PLES I GEOTHERMAL DEVELOPMENT PROJECT

FINAL ENVIRONMENTAL IMPACT STATEMENT AND SUPPLEMENTAL ENVIRONMENTAL IMPACT REPORT

June 1989

FIGURE 2-1
Proposed Project Site Plan

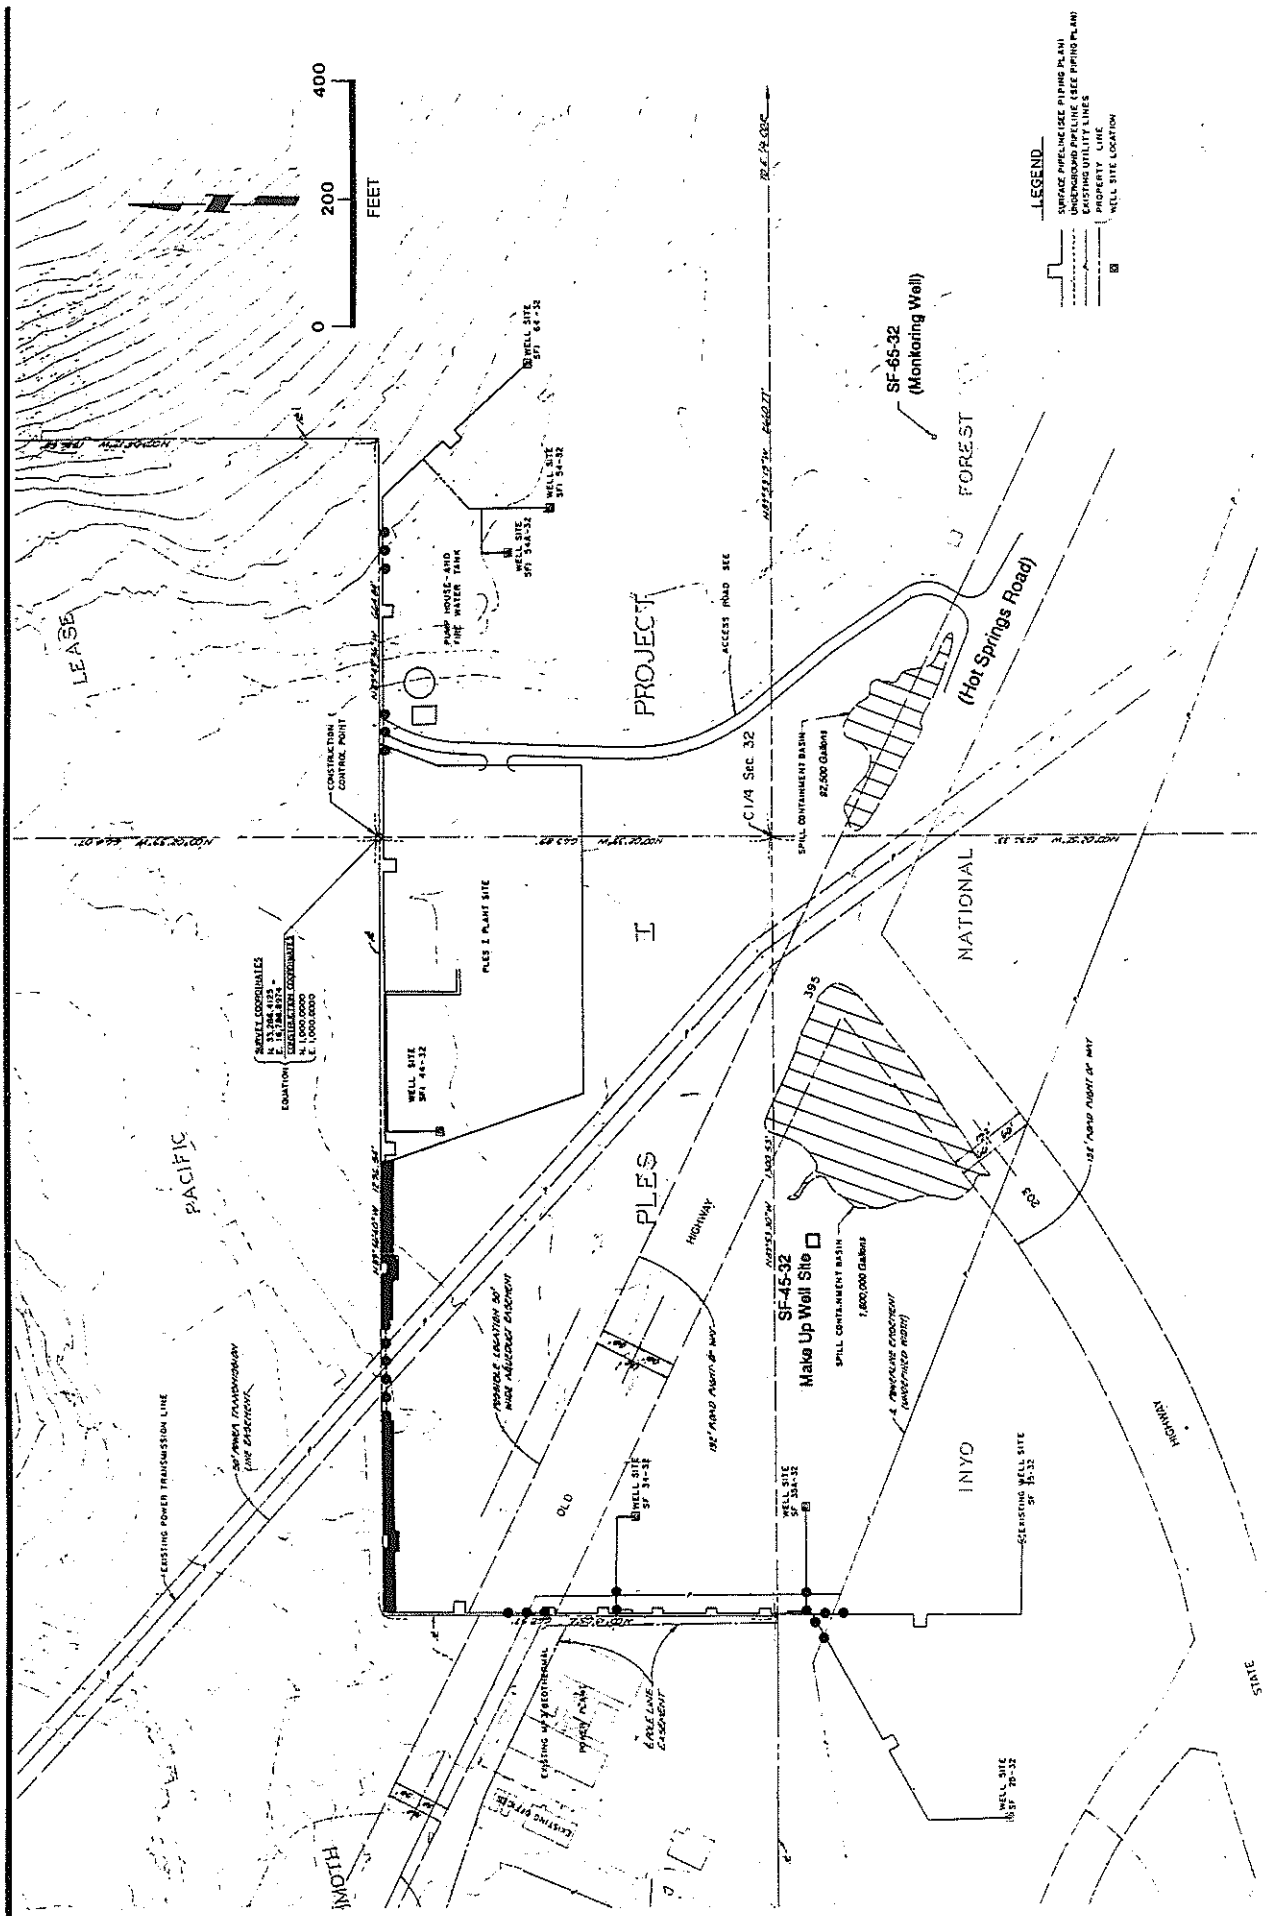
6-8 Page 2-15, "Gathering System" describes the layout and construction techniques used in pipeline layout. Nowhere in this description does it say that there will be "underground piping". This is in conflict with Figure 2-1 which indicates that segments of the pipeline will be "underground piping", as compared to being "below grade" in an open trench. The difference between these two will have significant detrimental or beneficial effects on migratory mule deer. This is also true of the description of the injection system described on page 2-21.

Response: A landscaping plan is part of the proposal and describes specifics of tree planting, painting schemes, pipeline locations, and lighting. The text has been edited to clarify this. The intended flexibility of pipeline location is limited to within a few feet of the location shown on Figure 2-1. See also response to comments 2-35, 2-64, etc, page 10-209.

FIGURE 2-6
Alternate Power Plant Location

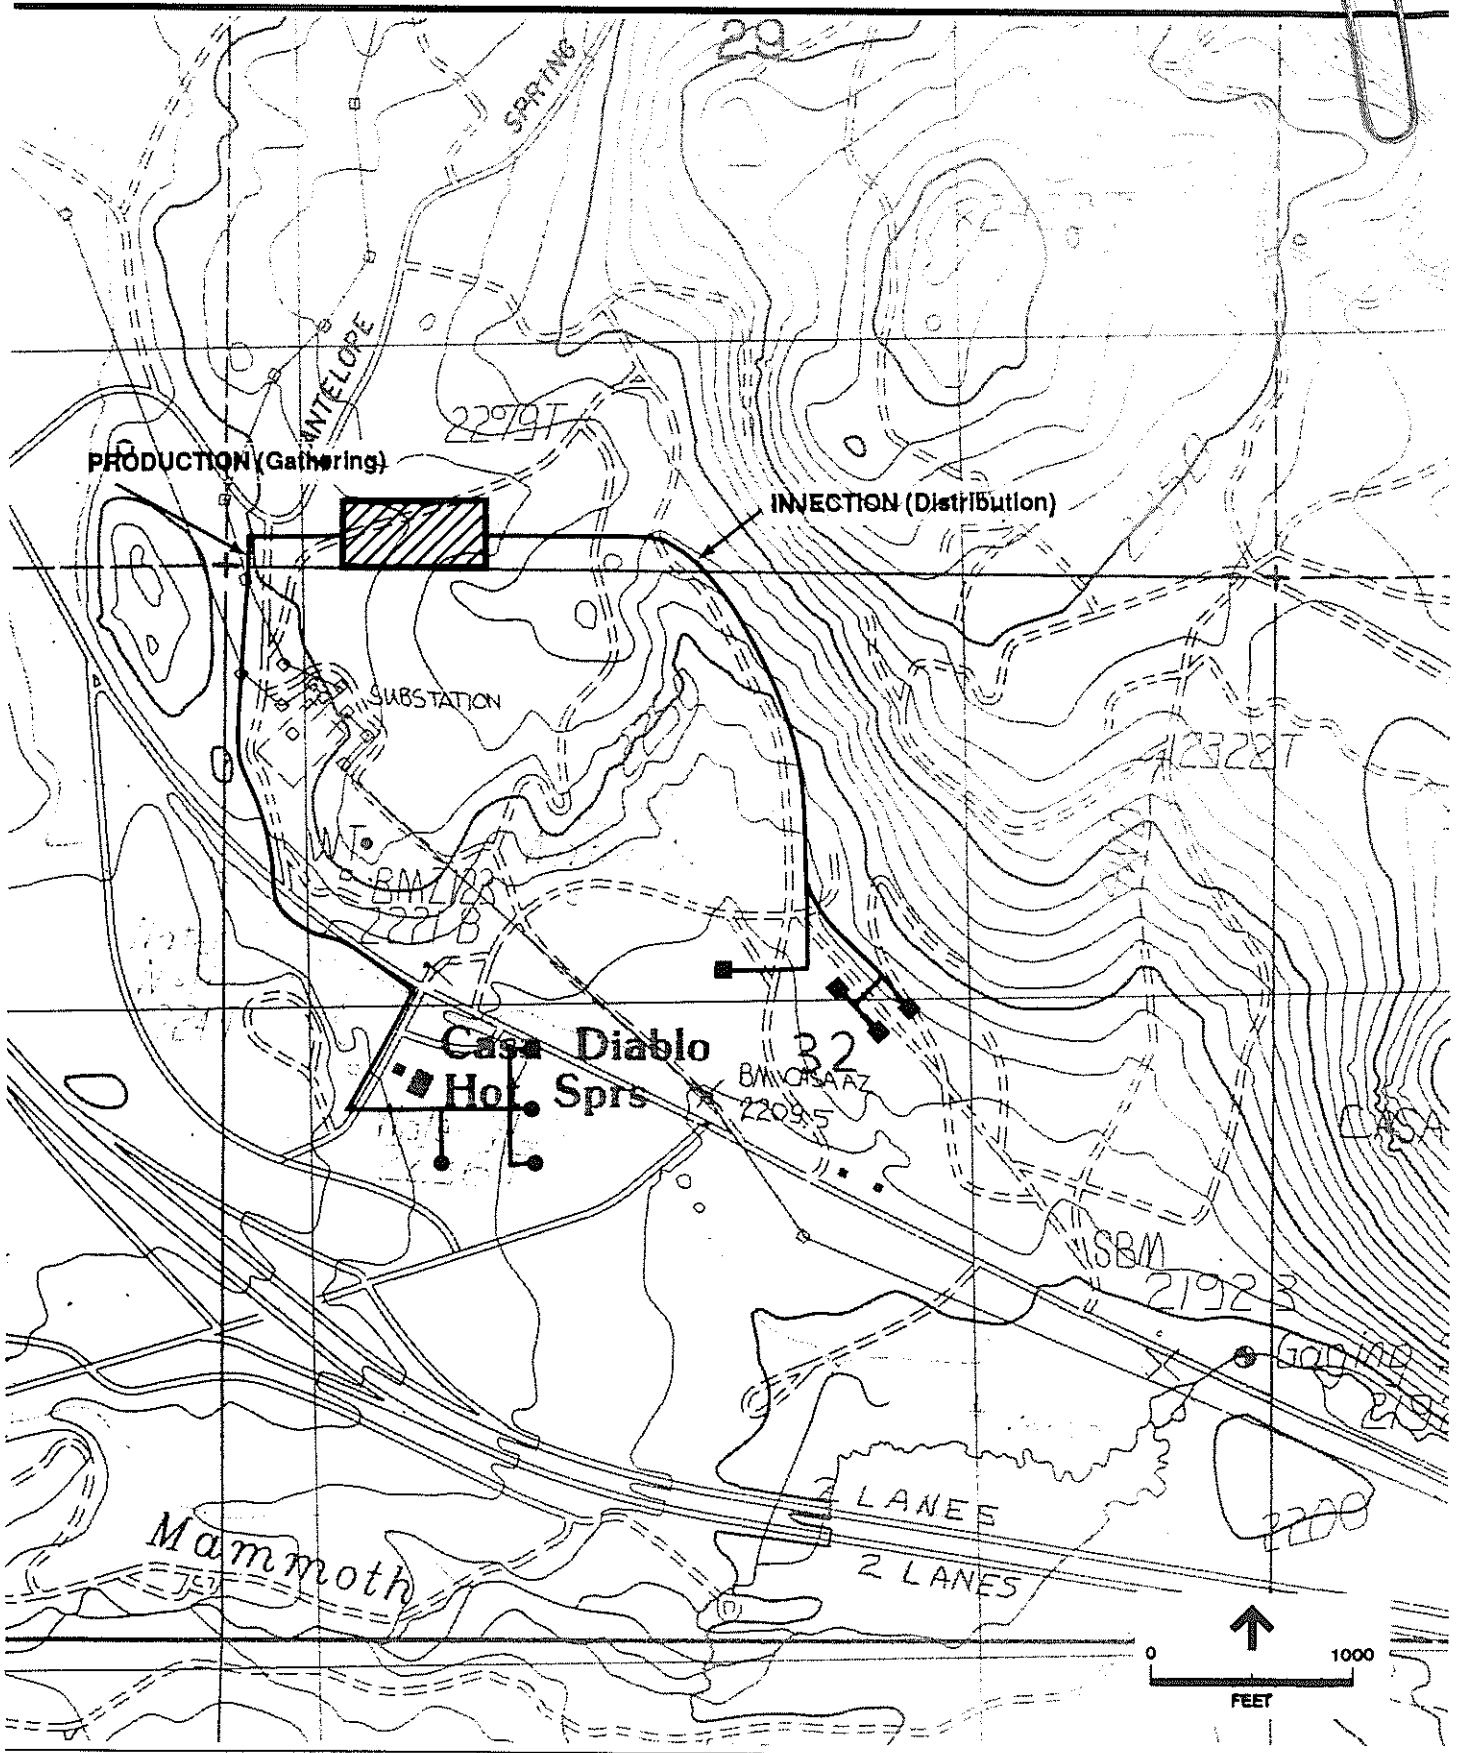
6-12 Figure 2-6 illustrates this underdeveloped alternative concept quite well when compared to Figure 2-1 ("preferred alternative"). Compare the level of detail that each of these figures provides. Which portions of the pipeline in figure 2-6 are to be placed in "excavated trenches"? Where is section 2.1.7.9 that supposedly describes this pipeline construction detail?

6-13 It is unclear from examining figure 2-6 exactly which of the sections of fluid transmission lines for this alternative will be buried or subgraded to mitigate impacts on migratory mule deer. How can permitting agencies evaluate such potential impacts lacking such information?

6-39c For instance, Figure 2-6 gives no indication of where or if these techniques will be used for the Alternative Site Facility Location. The mitigation listed for this impact under the Alternative Location impacts is to locate the power plant in the "preferred" location. This is a prime example of how the DEIS handles its treatment of alternatives throughout. In this case, the mitigation should focus on the resource as affected by the alternative in question, not simply refer back to the preferred location to solve the problem. This type of treatment of alternatives is another serious deficiency of the DEIS.

FIGURE: 3-5
Habitat Type Map

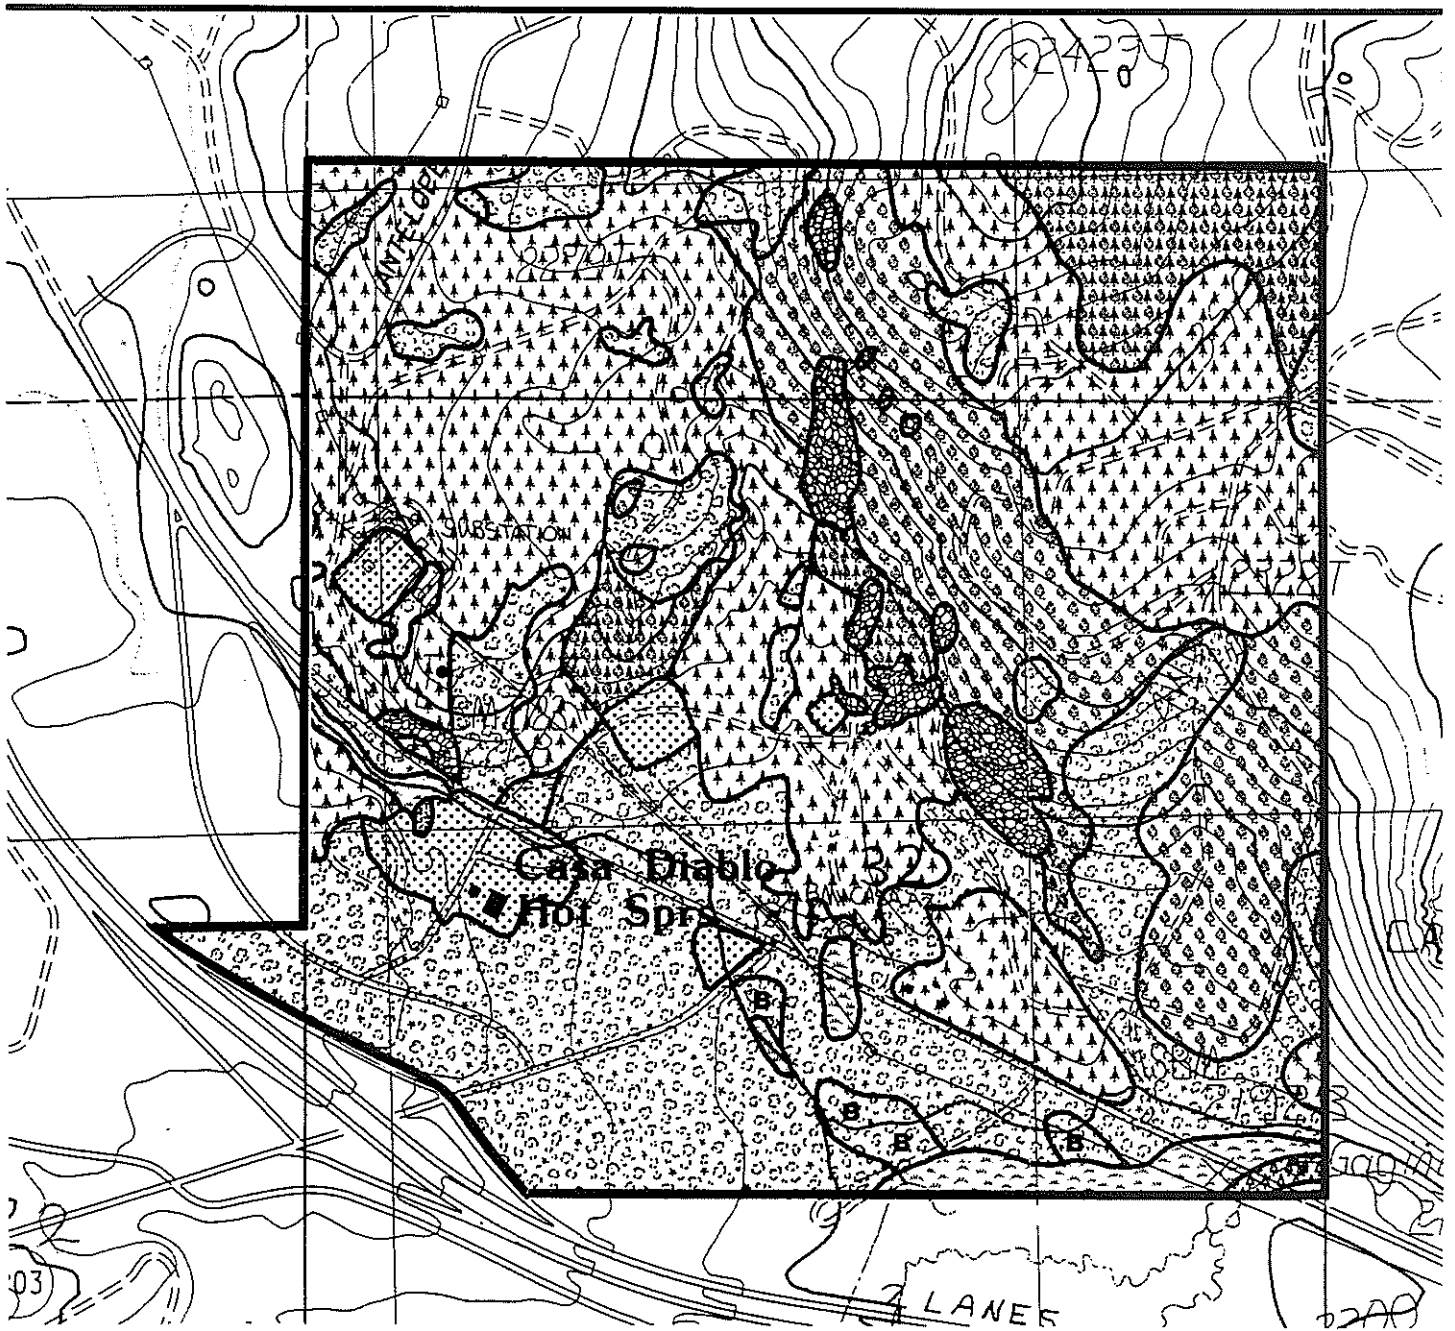
Page 3-36 Figure 3-5 Here is another example of the lack of detail in the DEIS for the "alternative site location". Why doesn't this map cover the areas occupied by all alternatives?

- 10-6 | 6. Page 3-36, Figure 3-5. This map should be extended to the west to cover the lands which could be affected by the alternate plant location.
- 10-7 | 7. Page 4-34, section 4.1.4.2.1 Proposed Project Impacts. If the cold water well lowers local groundwater levels, would that have an impact on the ephemeral ponds to the west? If so, how could that be mitigated? This question should be addressed in the final EIS.

Response: All habitat types in the immediate area could be affected, although the text has been revised to clarify the point. See Figure 3-5.
